S.4.55(1A) APPLICATION
STATEMENT OF MODIFICATION & ENVIRONMENTAL EFFECTS
1 Tabalum Road Balgowlah Heights

Development Consent DA2020/0077

Demolition works and construction of a new dwelling

1 Tabalum Road Balgowlah Heights

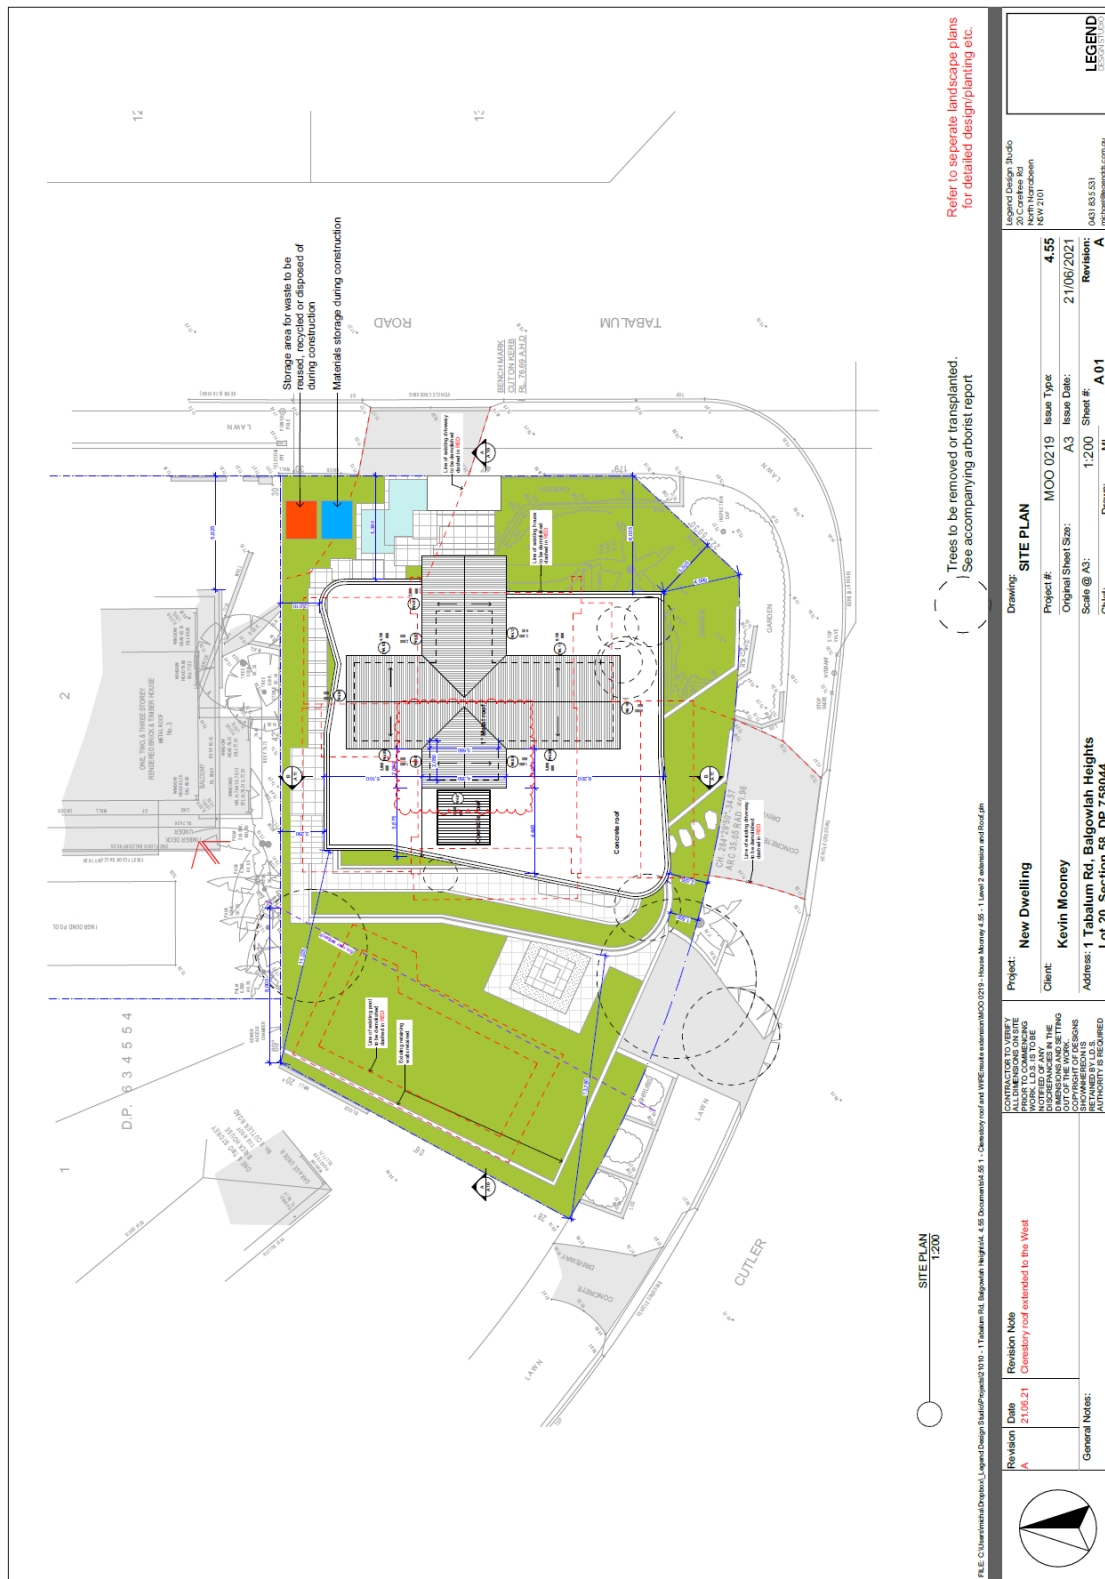
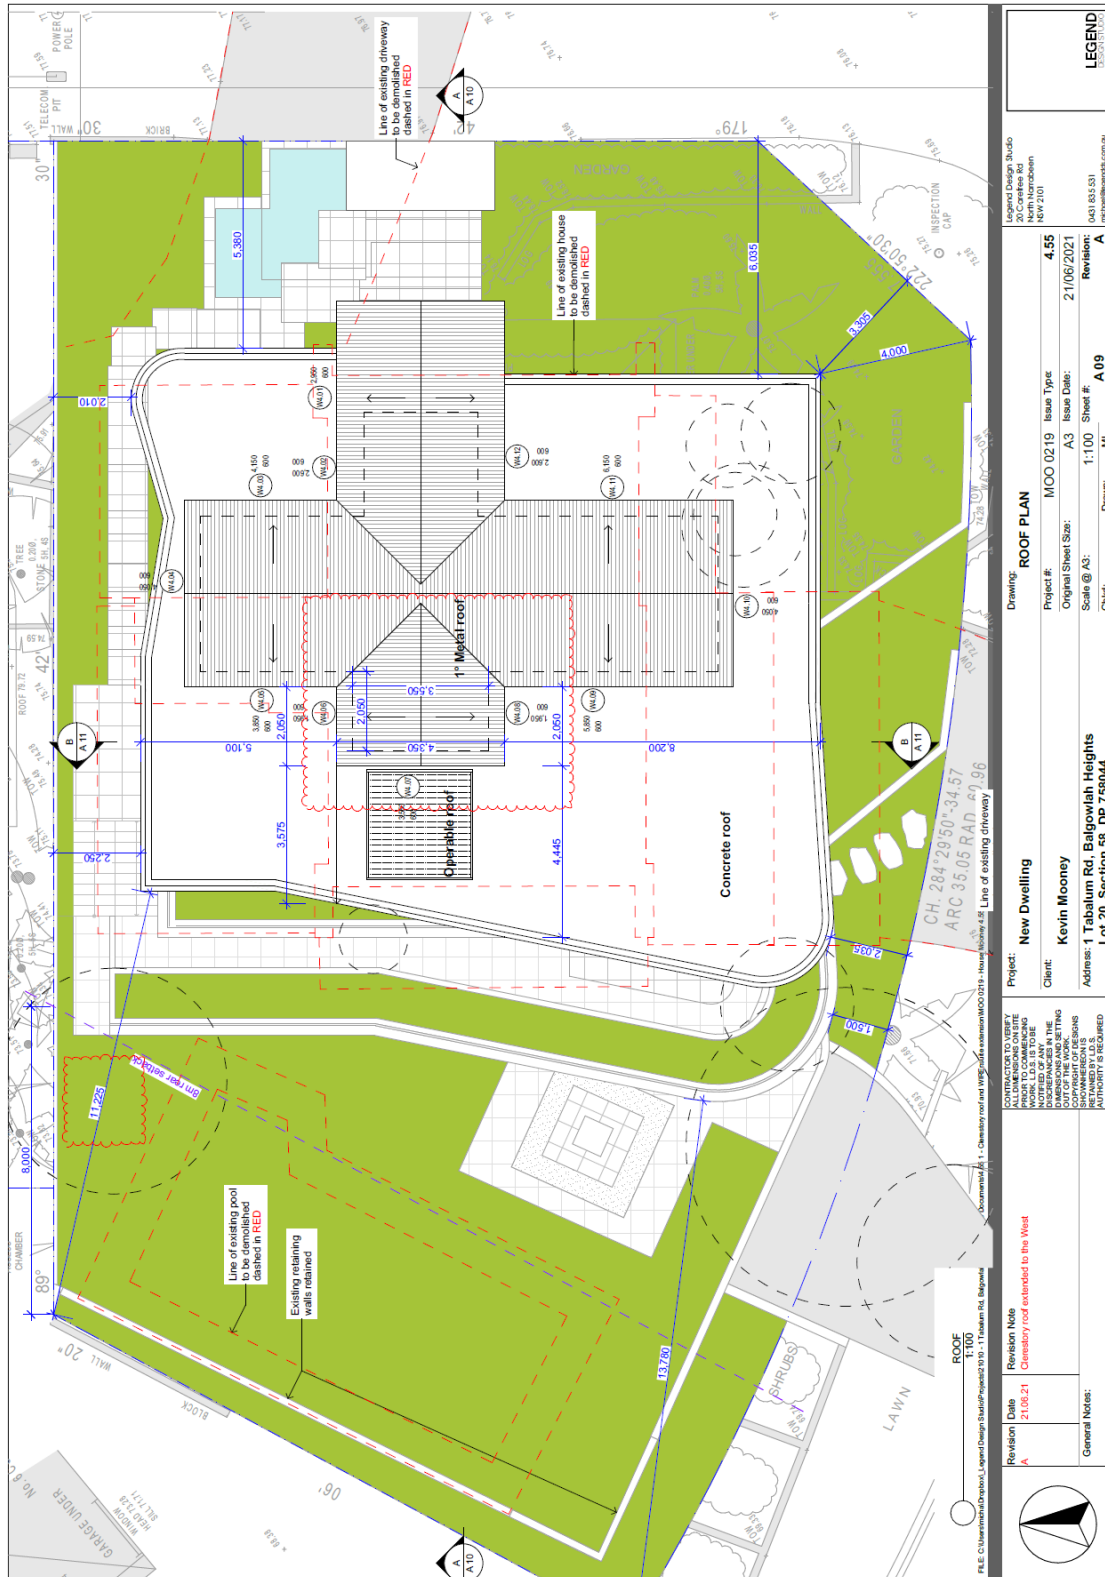
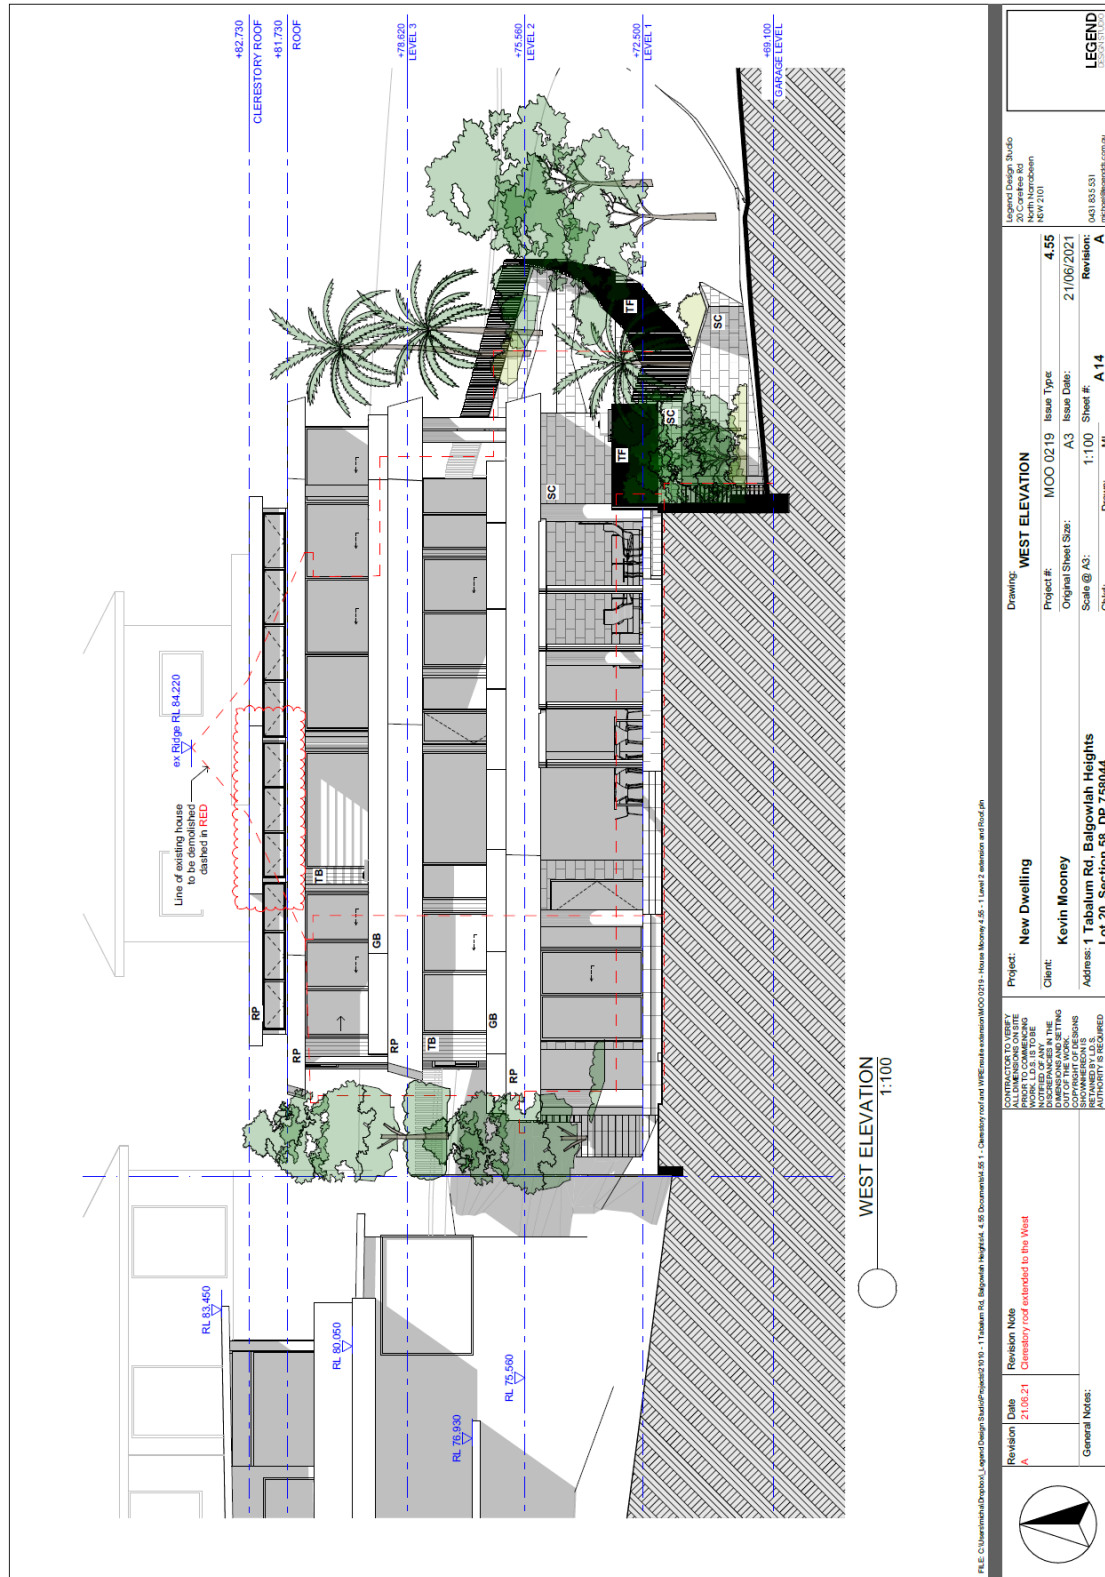
<p>Revision</p> <p>Date</p> <p>Revision Note</p> <p>21.06.21</p> <p>Clerestory roof extended to the West</p>	<p>Project:</p> <p>New Dwelling</p> <p>Client:</p> <p>Kevin Mooney</p> <p>Address: 1 Tabalum Rd, Balgownie Heights Lot 20, Section 58, DP 758044</p>	<p>Drawing:</p> <p>WEST ELEVATION</p> <p>Project #: MOO 0219</p> <p>Issue Type: 4.55</p> <p>Original Sheet Size: A3</p> <p>Issue Date: 21/06/2021</p> <p>Scale @ A3: 1:100</p> <p>Sheet #: A14</p> <p>Revisions:</p> <p>Drawn: ML</p> <p>Checked: A</p>	<p>Legend</p> <p>MOO0219.01</p> <p>MOO0219.02</p> <p>MOO0219.03</p> <p>MOO0219.04</p> <p>MOO0219.05</p> <p>MOO0219.06</p> <p>MOO0219.07</p> <p>MOO0219.08</p> <p>MOO0219.09</p> <p>MOO0219.10</p> <p>MOO0219.11</p> <p>MOO0219.12</p> <p>MOO0219.13</p> <p>MOO0219.14</p> <p>MOO0219.15</p> <p>MOO0219.16</p> <p>MOO0219.17</p> <p>MOO0219.18</p> <p>MOO0219.19</p> <p>MOO0219.20</p> <p>MOO0219.21</p> <p>MOO0219.22</p> <p>MOO0219.23</p> <p>MOO0219.24</p> <p>MOO0219.25</p> <p>MOO0219.26</p> <p>MOO0219.27</p> <p>MOO0219.28</p> <p>MOO0219.29</p> <p>MOO0219.30</p> <p>MOO0219.31</p> <p>MOO0219.32</p> <p>MOO0219.33</p> <p>MOO0219.34</p> <p>MOO0219.35</p> <p>MOO0219.36</p> <p>MOO0219.37</p> <p>MOO0219.38</p> <p>MOO0219.39</p> <p>MOO0219.40</p> <p>MOO0219.41</p> <p>MOO0219.42</p> <p>MOO0219.43</p> <p>MOO0219.44</p> <p>MOO0219.45</p> <p>MOO0219.46</p> <p>MOO0219.47</p> <p>MOO0219.48</p> <p>MOO0219.49</p> <p>MOO0219.50</p> <p>MOO0219.51</p> <p>MOO0219.52</p> <p>MOO0219.53</p> <p>MOO0219.54</p> <p>MOO0219.55</p> <p>MOO0219.56</p> <p>MOO0219.57</p> <p>MOO0219.58</p> <p>MOO0219.59</p> <p>MOO0219.60</p> <p>MOO0219.61</p> <p>MOO0219.62</p> <p>MOO0219.63</p> <p>MOO0219.64</p> <p>MOO0219.65</p> <p>MOO0219.66</p> <p>MOO0219.67</p> <p>MOO0219.68</p> <p>MOO0219.69</p> <p>MOO0219.70</p> <p>MOO0219.71</p> <p>MOO0219.72</p> <p>MOO0219.73</p> <p>MOO0219.74</p> <p>MOO0219.75</p> <p>MOO0219.76</p> <p>MOO0219.77</p> <p>MOO0219.78</p> <p>MOO0219.79</p> <p>MOO0219.80</p> <p>MOO0219.81</p> <p>MOO0219.82</p> <p>MOO0219.83</p> <p>MOO0219.84</p> <p>MOO0219.85</p> <p>MOO0219.86</p> <p>MOO0219.87</p> <p>MOO0219.88</p> <p>MOO0219.89</p> <p>MOO0219.90</p> <p>MOO0219.91</p> <p>MOO0219.92</p> <p>MOO0219.93</p> <p>MOO0219.94</p> <p>MOO0219.95</p> <p>MOO0219.96</p> <p>MOO0219.97</p> <p>MOO0219.98</p> <p>MOO0219.99</p> <p>MOO0219.100</p>

No visible change when viewed from Tabalum Rd.

Drawing: VIEW ANALYSIS FROM #2 TABALUM RD
Project #: MOO 0219 Issue Type: 4.55
Original Sheet Size: A3 Issue Date: 21/06/2021
Scale @ A3: 1:1 Sheet #: A25 Revision: A
Client: ML

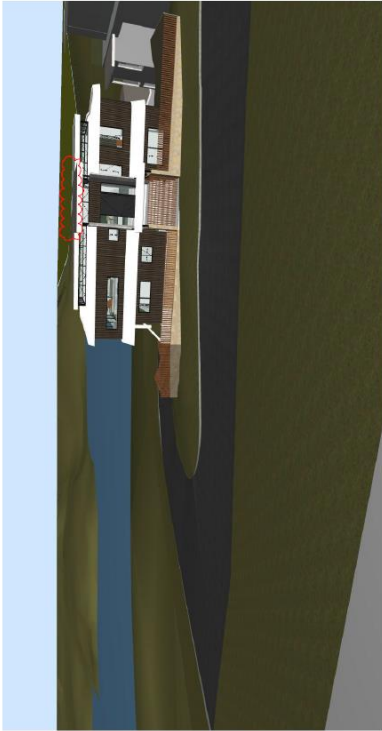
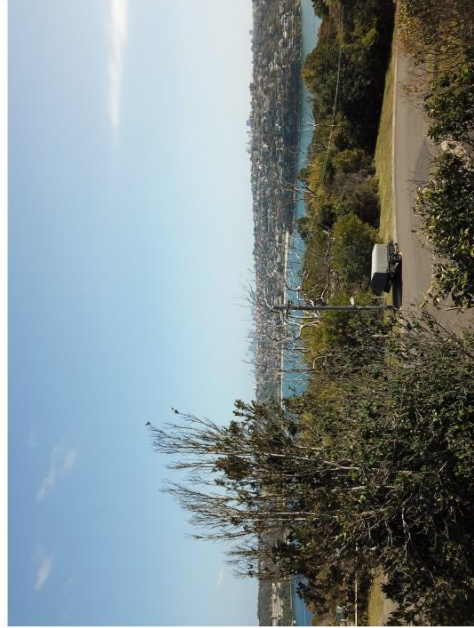
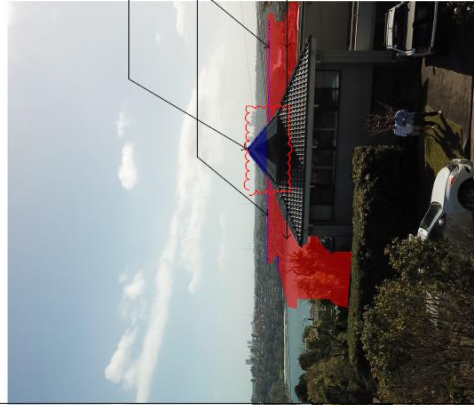
Revision: A Date: 21/06/21
Revision Note: Clerestory roof extended to the West

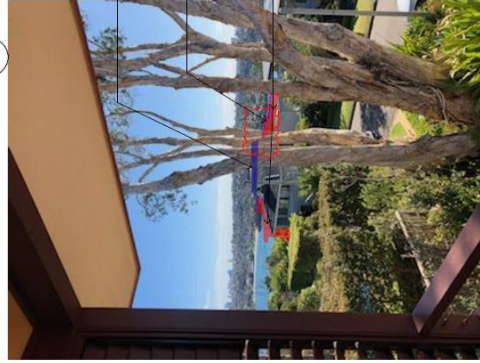
Net view gain from proposed dwelling shown in **PURPLE**

8.5m height limit line shown in **BLUE**.
(See elevations and sections)
Proposed dwelling complies with this 8.5m height limit

Net view loss (mitior) from proposed dwelling shown in **RED**

Revision	Date	Revision Note
A	21/06/21	Consistency roof extended to the West
General Notes:		
CONTRACTOR TO VERIFY ALL DIMENSIONS ON SITE. WORKING TO THE DIMENSIONS SHOWN IN THE DRAWINGS. DIMENSIONS OUT OF THE WORK SHALL BE THE RESPONSIBILITY OF THE CONTRACTOR. DIMENSIONS OUT OF THE WORK SHALL BE THE RESPONSIBILITY OF THE CONTRACTOR. DIMENSIONS OUT OF THE WORK SHALL BE THE RESPONSIBILITY OF THE CONTRACTOR.
